Final Drainage Report

# Eagleview Subdivision El Paso County, Colorado

Prepared: December 23, 2022

Please add PCD File  
# SF-22-42

## West Tributary – Existing Conditions

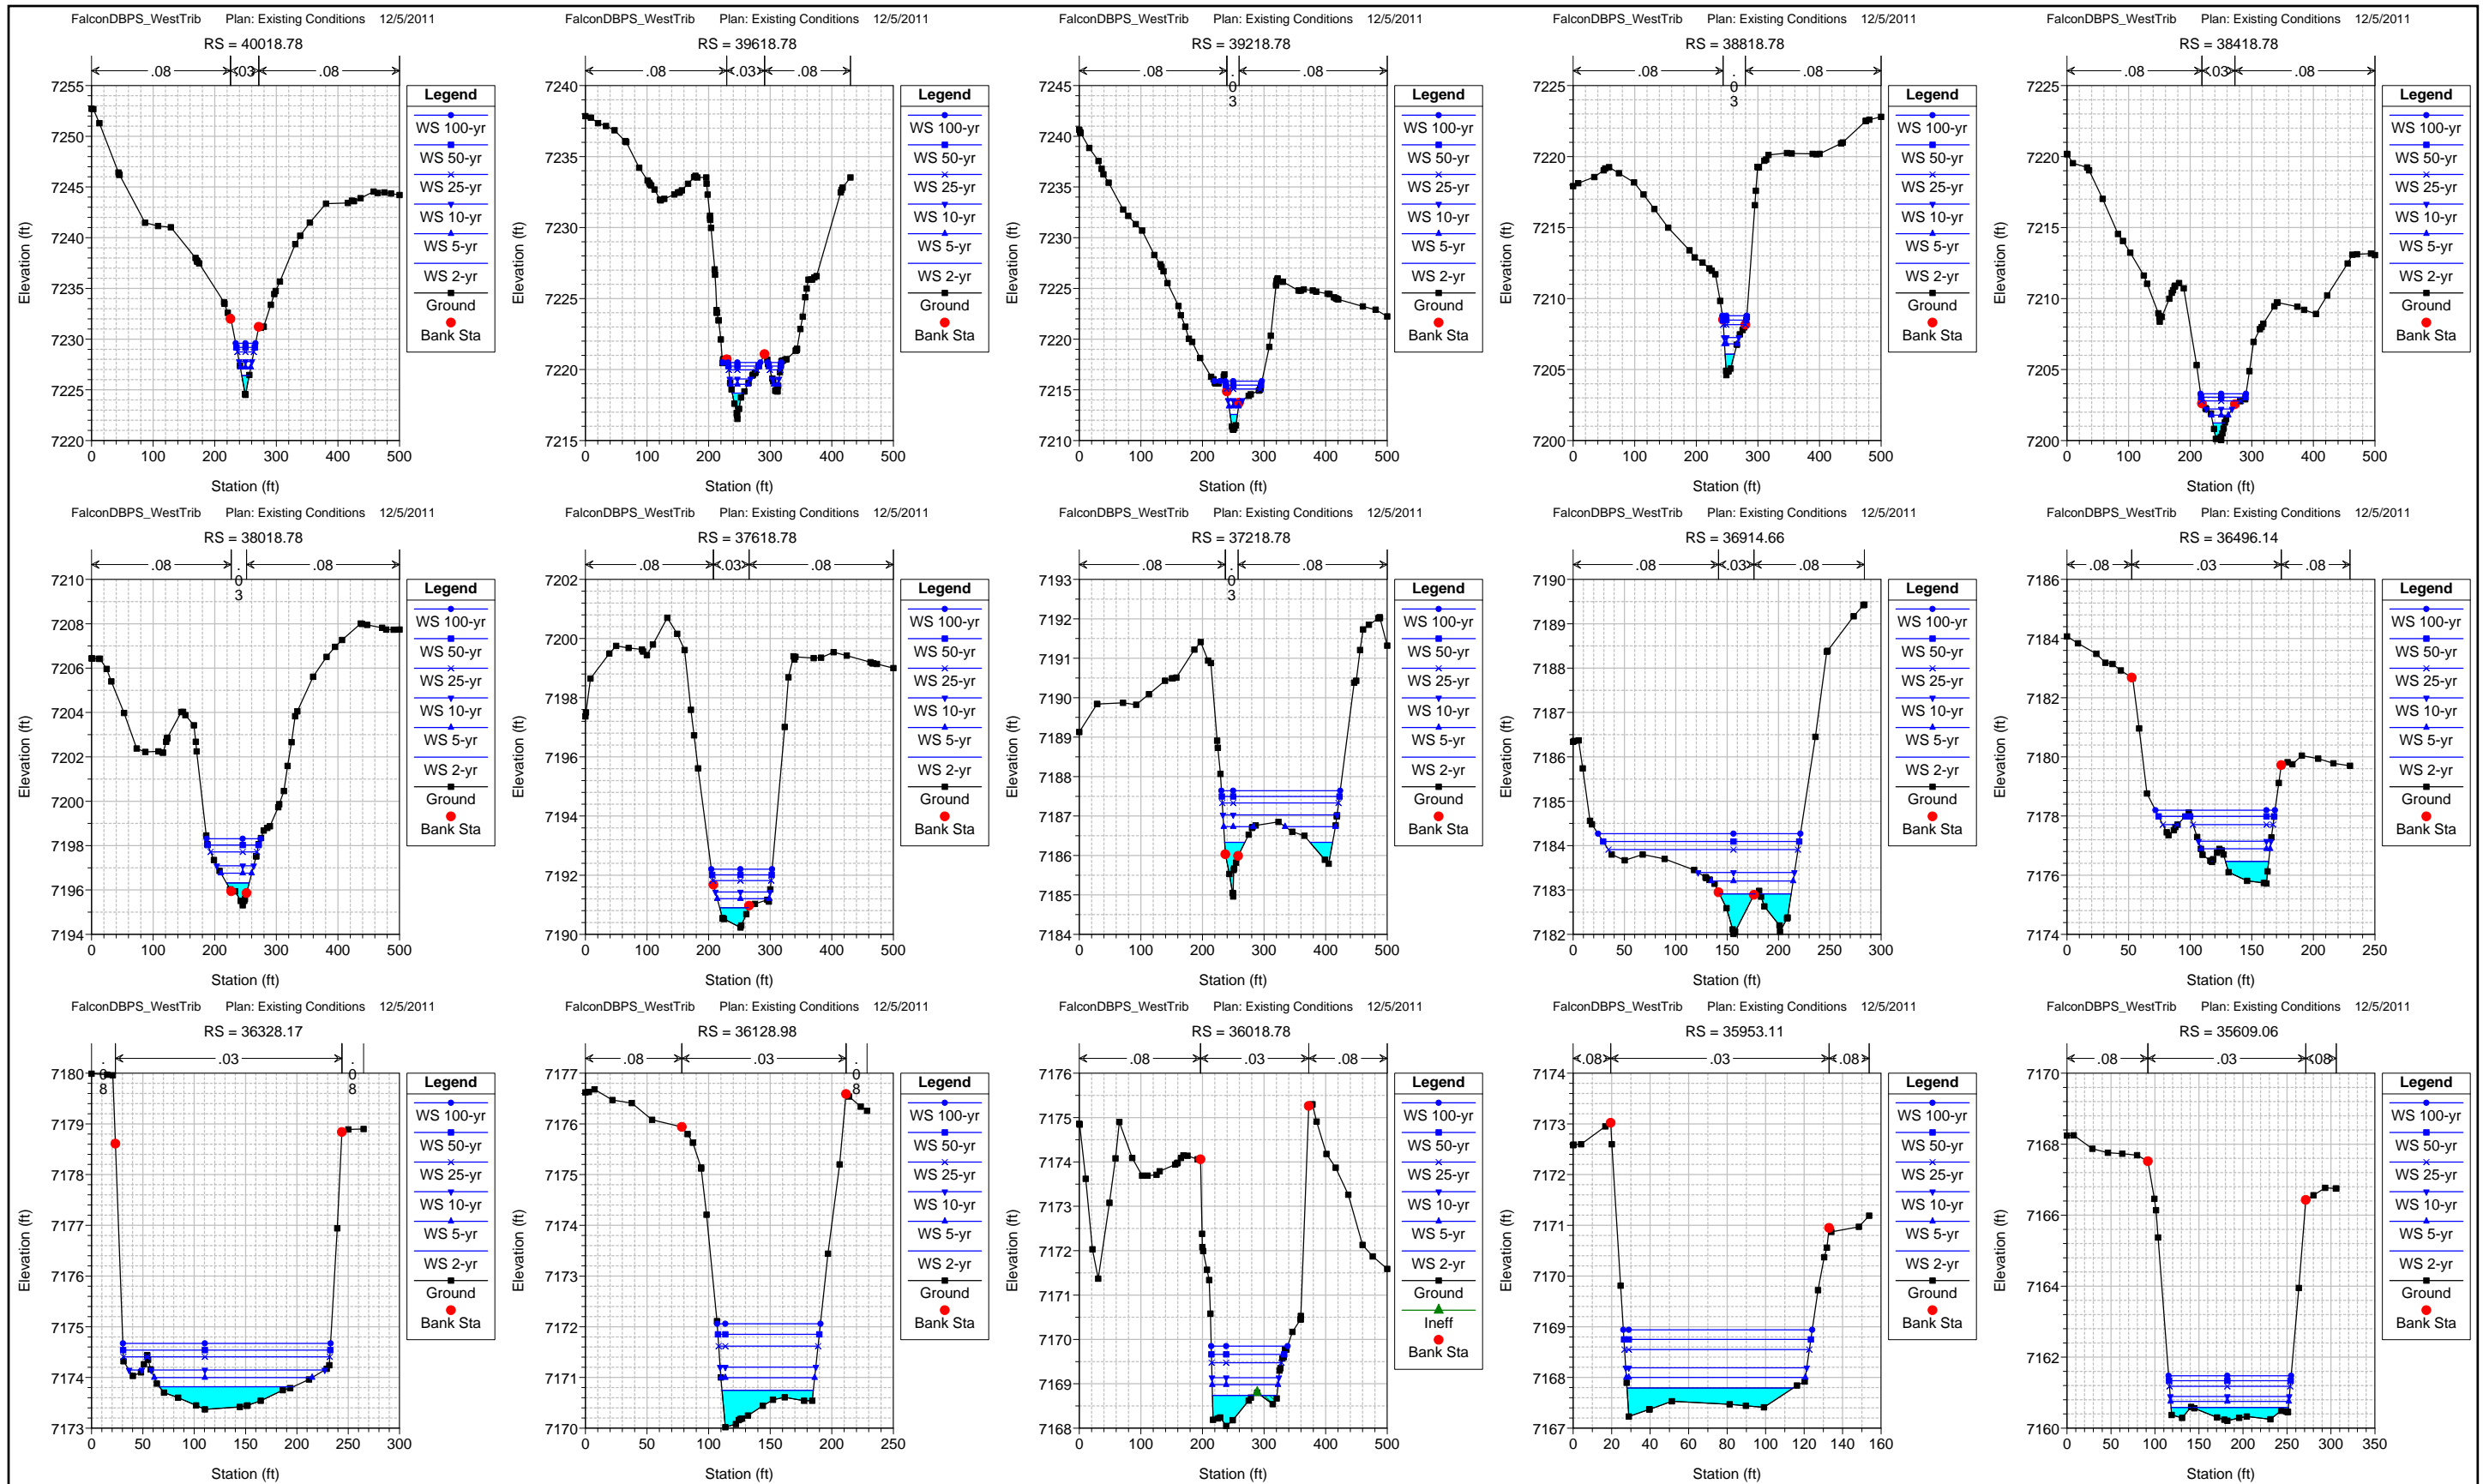
Provide an existing and proposed HEC-RAS Map showing the cross section cuts.

Contact the review engineer to discuss. Is the HEC-RAS included from the DBPS? Is there going to be a separate modeling specific to the proposed improvements?

Not clear why this is included in the report. It seems this can be removed.

EAGLEVIEW  
 EL PASO COUNTY, COLORADO  
 POST DEVELOPMENT - DRAINAGE MAP

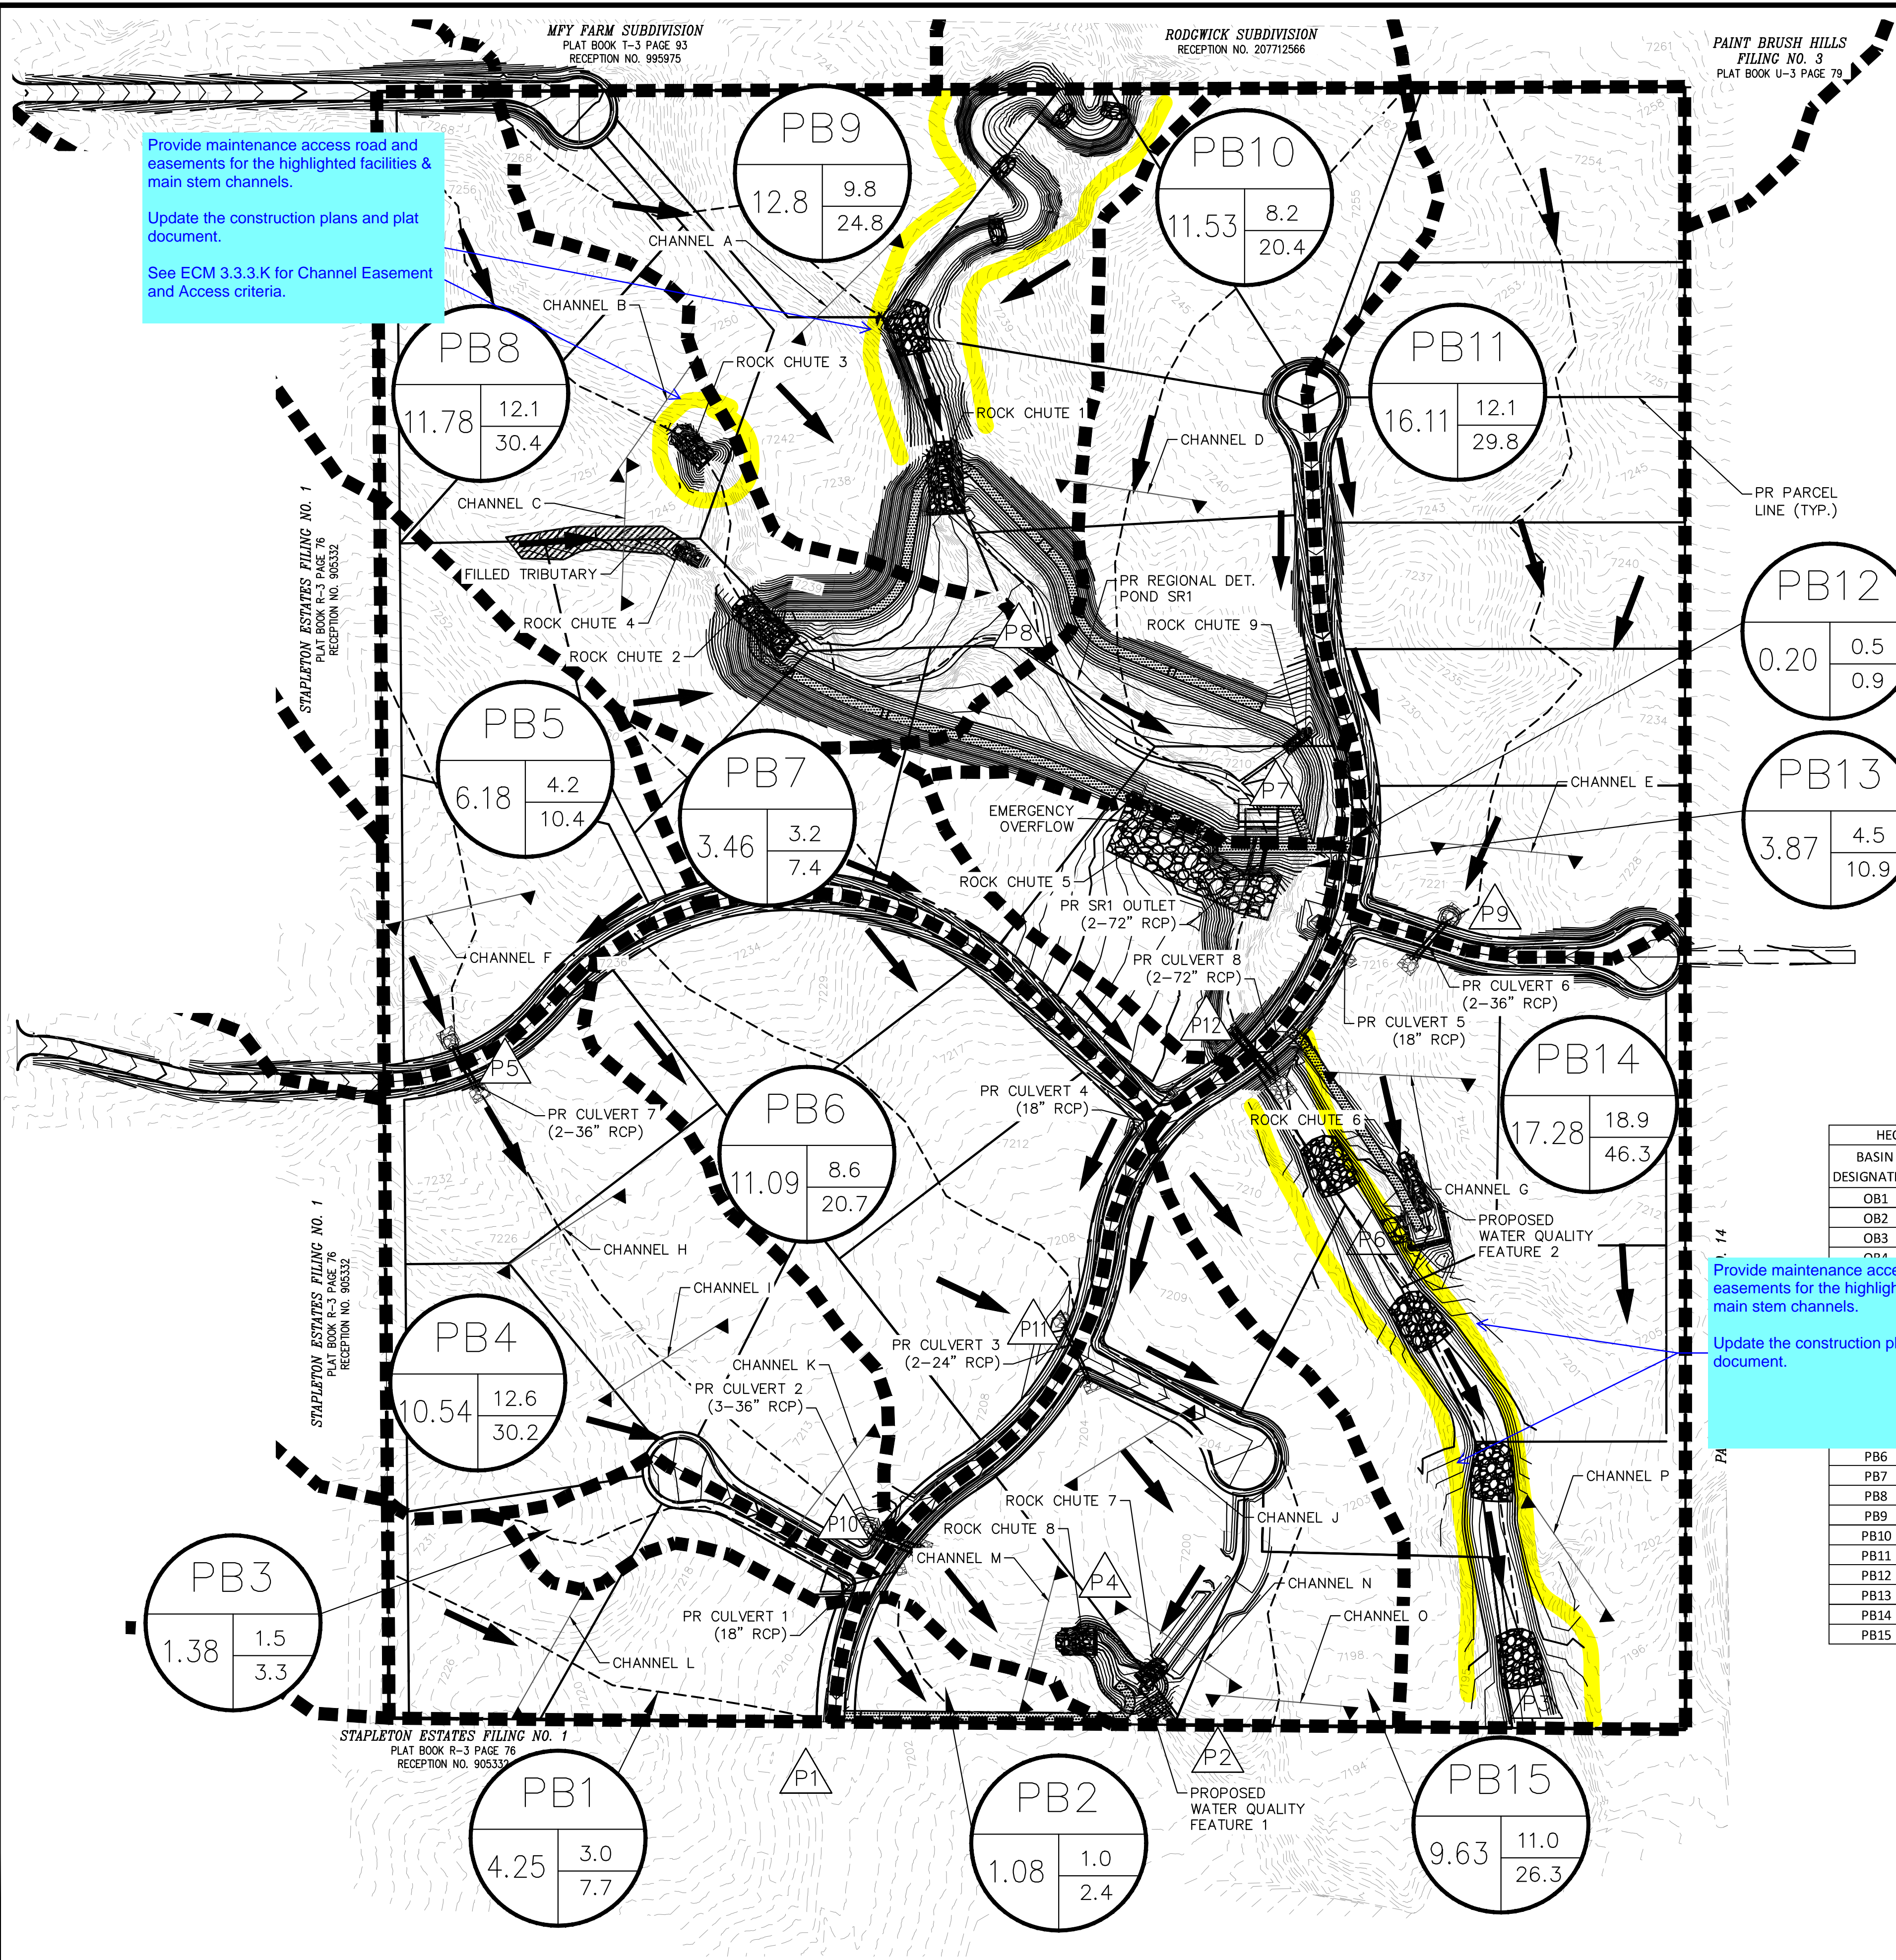
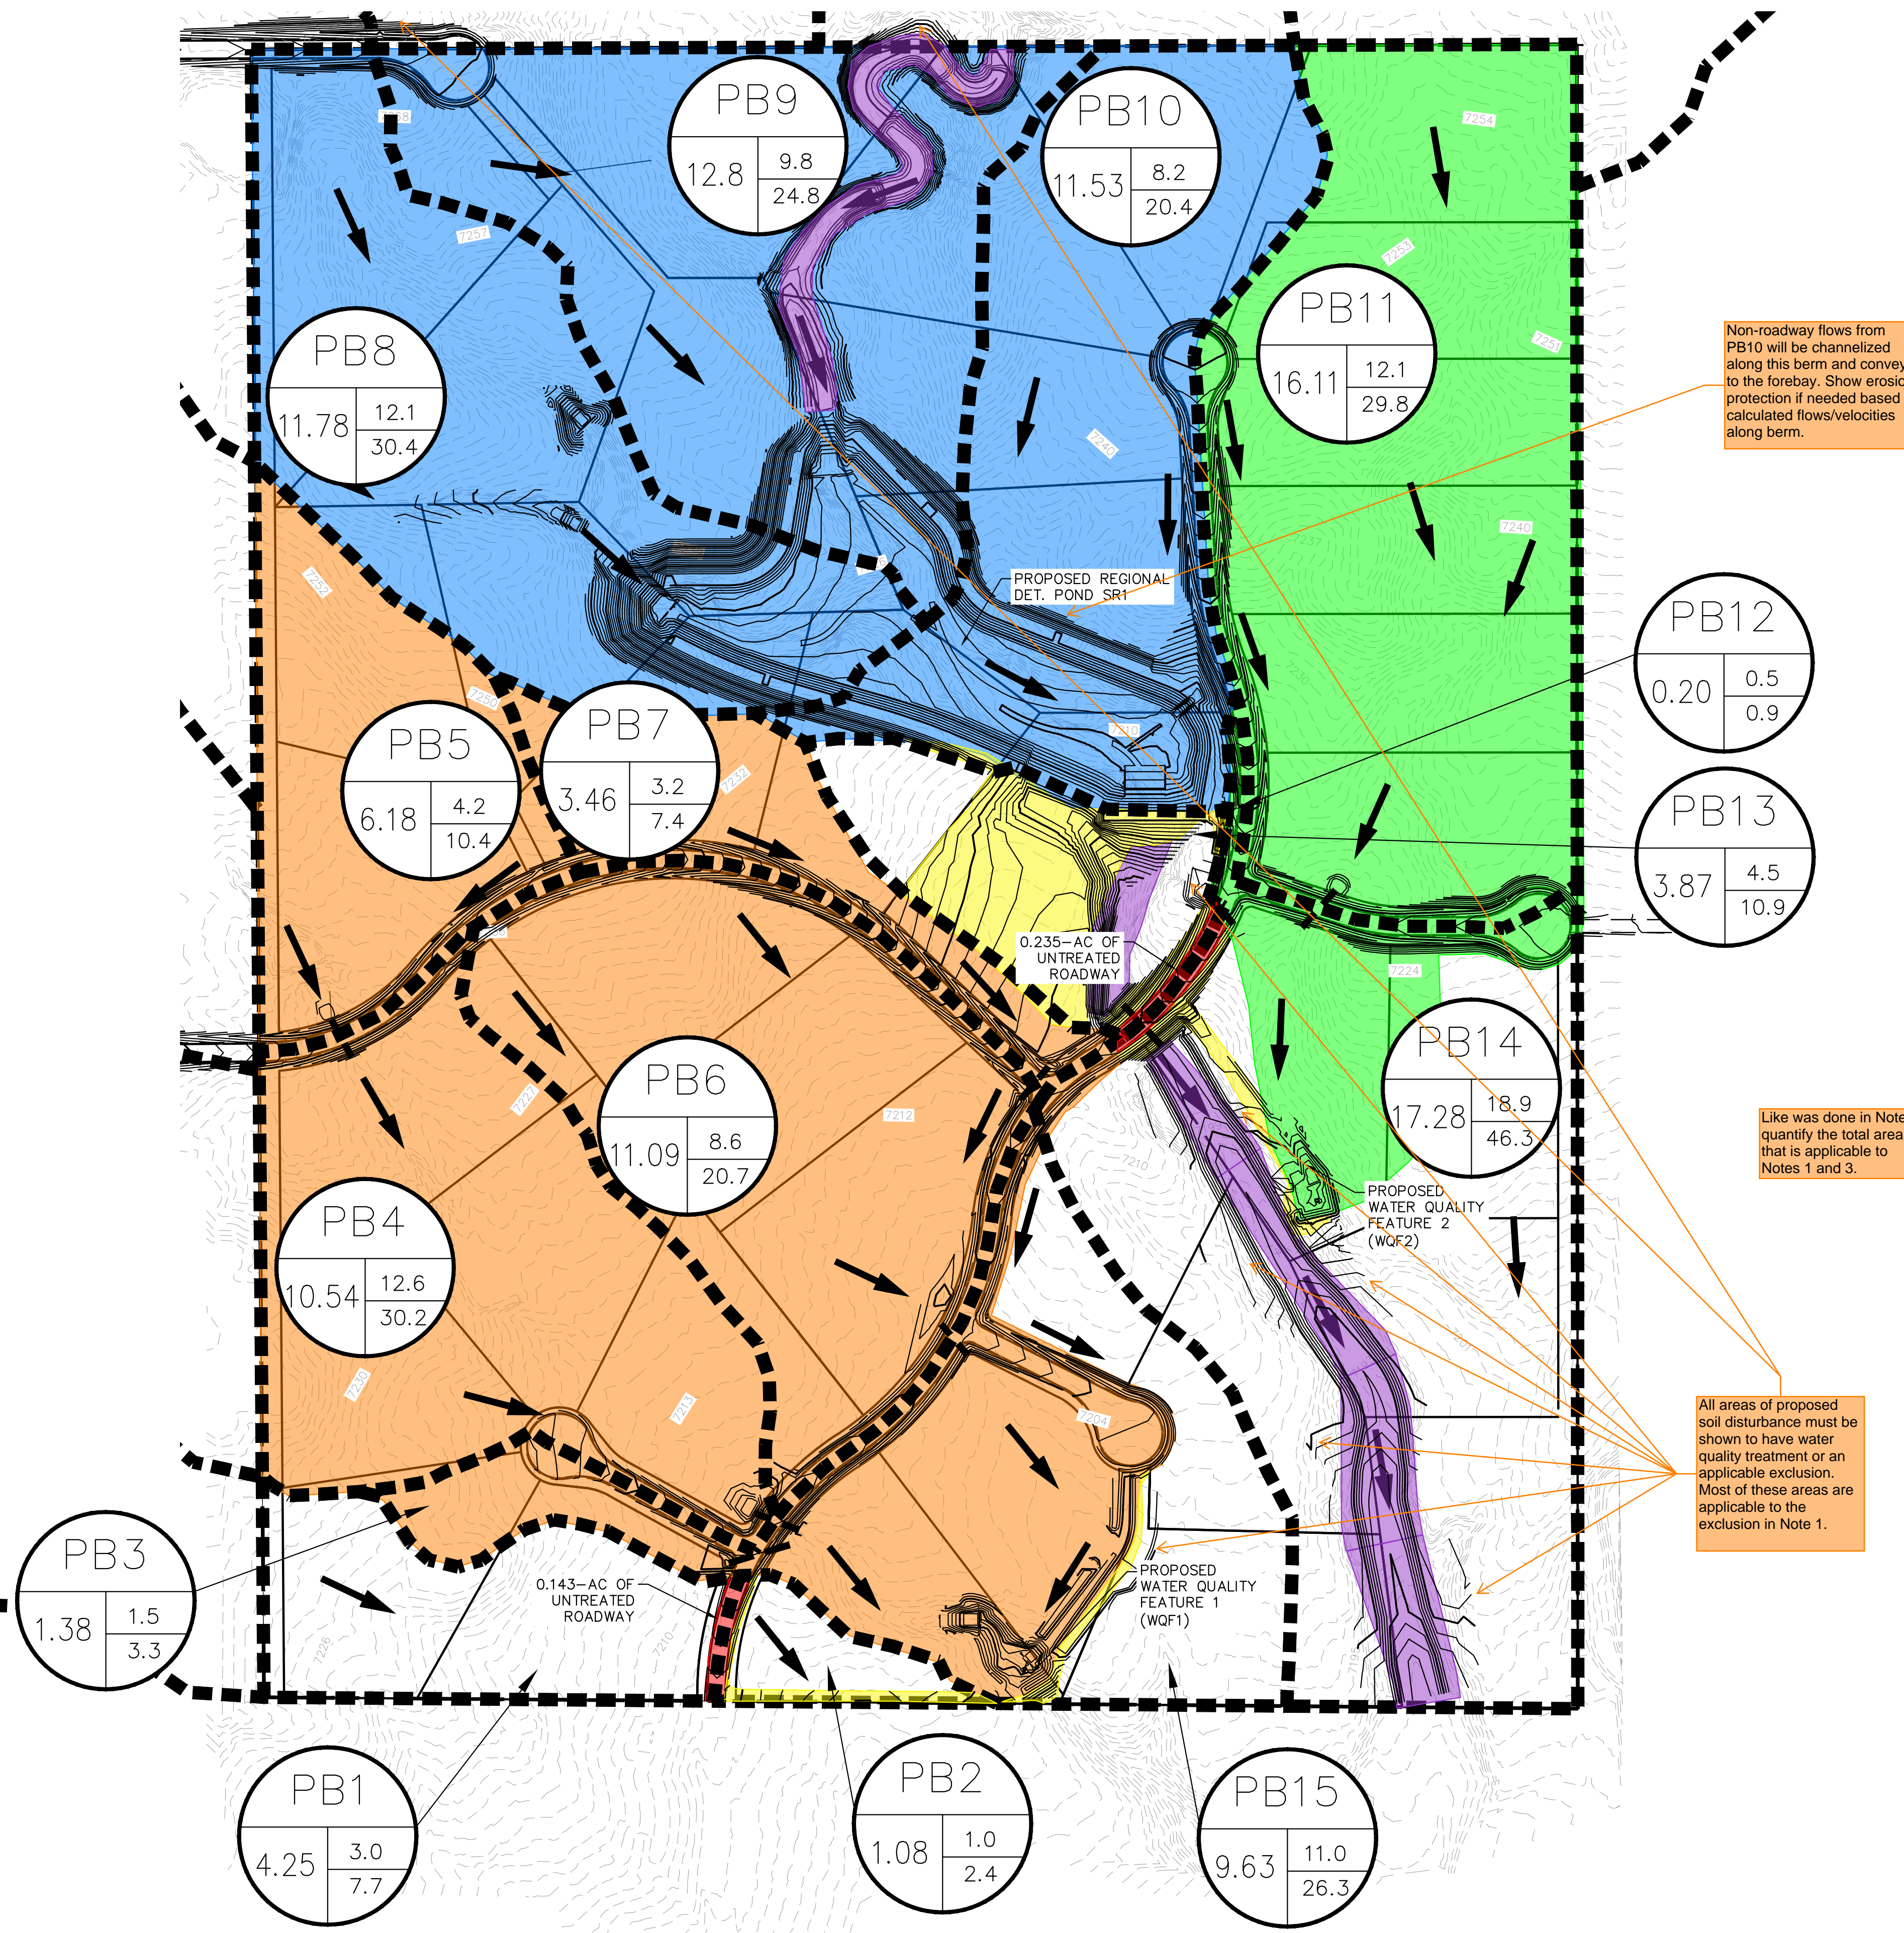
Provide maintenance access road and easements for the highlighted facilities & main stem channels.  
 Update the construction plans and plat document.  
 See ECM 3.3.3.K for Channel Easement and Access criteria.
